The Alternatives Hydro Power Project

**The Alternatives Hydro Power Project
FERC No. 12608-000 -MA
EXHIBIT F-1**

Reference: Water Quality/Monitoring Plan
The Alternatives Hydro Power Project
FERC Project No. 12608-00
Northbridge, Massachusetts
BTI Project No. 968.10

Run-of-River Monitoring Plan

Figure 1: Water Level Monitoring Locations

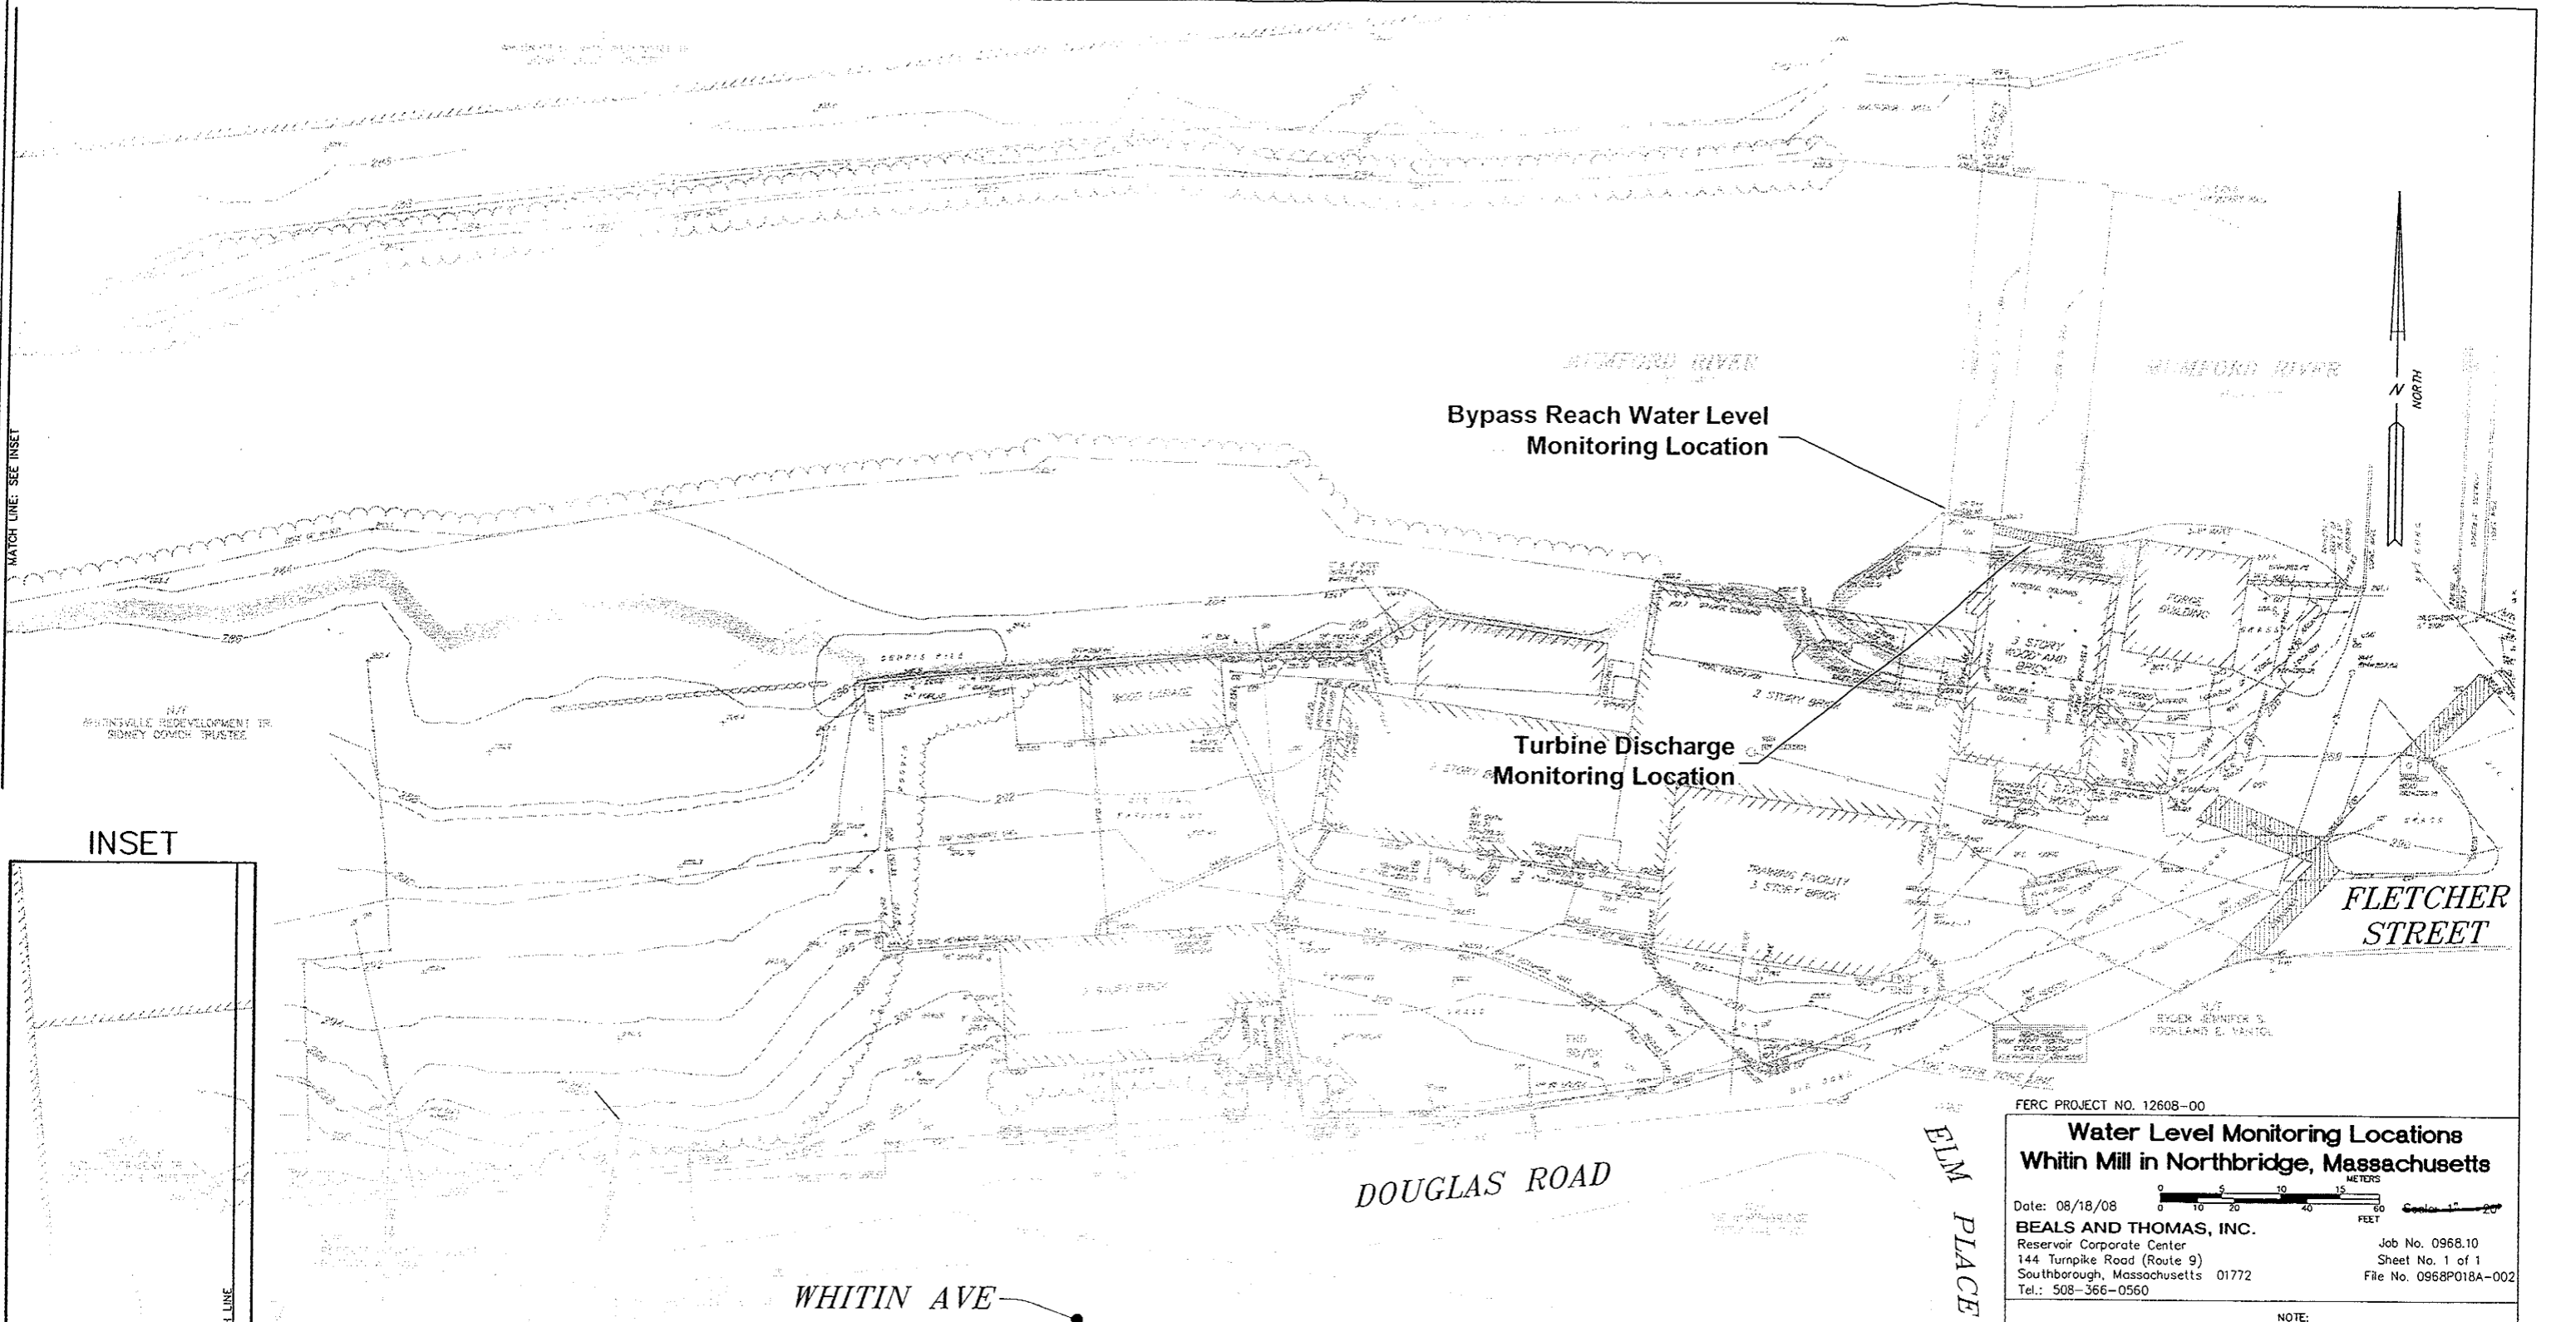
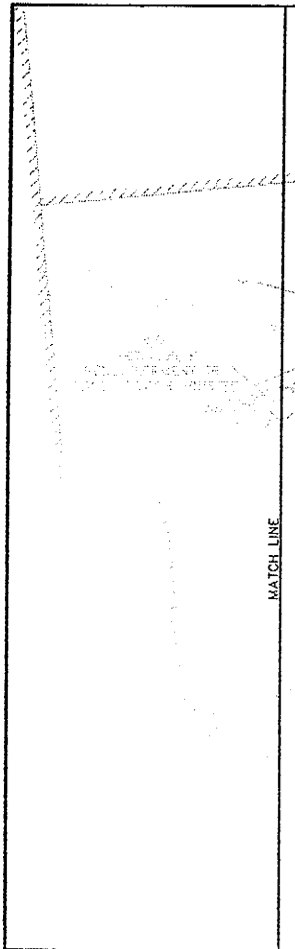
- Throughout the plan, Alternatives uses the term “bypass” to describe the generating equipment. This terminology is confusing and should be changed, as resource agencies typically use that word to describe the reach of river between the dam and the tailrace discharge.

- The pond leveling device should be described in more detail. In general, new projects typically propose to use headpond level sensors in combination with a Programmable Logic Controller (PLC) and full SCADA controls. This type of system allows for the continuous, closed loop automatic adjustment of the turbine wicket gates and runner blade positions to maintain a specified water level that should ensure run-of-river operation and the required spillway discharge are continuously maintained.

- If a sensor/PLC/SCADA system will be used, the plan will need to specify the target water surface elevations for the Start, Run, and Stop settings of the control system. According to the draft plan, the top-of-boards elevation is 285.1 feet NAVD. In order to meet the spillway discharge condition, the headpond would need to be maintained at or above 285.2 feet NAVD (this elevation may need to be increased depending on the accuracy and operational tolerances of the equipment).

- The plan should contain a discussion of how the monitoring equipment will be calibrated and maintained.
- It appears that Alternatives proposes to manually record turbine discharge and staff gauge readings, then enter them into a spreadsheet that would be available for agency inspection. The staff gauge would be read weekly, while no frequency is specified for taking turbine discharge measurements. Reading and recording measurements at any interval greater than hourly is unacceptable. Typically, PLC-SCADA systems will automatically read and record water surface elevation and station generation at 15- or 30-minute intervals by a datalogger. The automation system does not directly measure turbine or spillway flow; rating curves are used to convert generation (in kW) to turbine flow, and water level elevations are used to calculate spillway discharge. We strongly recommend that Alternatives adopt this type of system (i.e., automatic, electronic, computer-based).

- By letter dated May 16, 2006, we provided mandatory Terms and Conditions for the project. Condition 4 mandates a procedure for refilling the impoundment after any drawdown to perform maintenance activities (including flashboard replacement) or for emergency purposes. The subject plan should contain a discussion of the protocol that will be followed to ensure compliance with Condition 4.

The Draft Plan is acceptable. In the final draft the water surface elevation datum cited should be consistent (NAVD or NGVD) or both should be used to avoid confusion. In section 1.0 the project impoundment water surface minimum elevation is described in both NGVD (284.6 feet) and NAVD (286.2 feet). In section 1.1 it is described only in NAVD (286.2 feet), then in the next section (2.0) it is only described in NAVD (286.2 feet) only, this cross reference allows the casual reader to assume that the project impoundment will be drawn down 6 inches (the difference between the two measurements) when in fact they are referring to the same elevation.

The final plan should reference the river flow at which the inflatable flashboards will deflate to allow maximum spillway capacity to pass this high flow and at what river flow they will re-inflate to maintain the project impoundment minimum surface elevation.
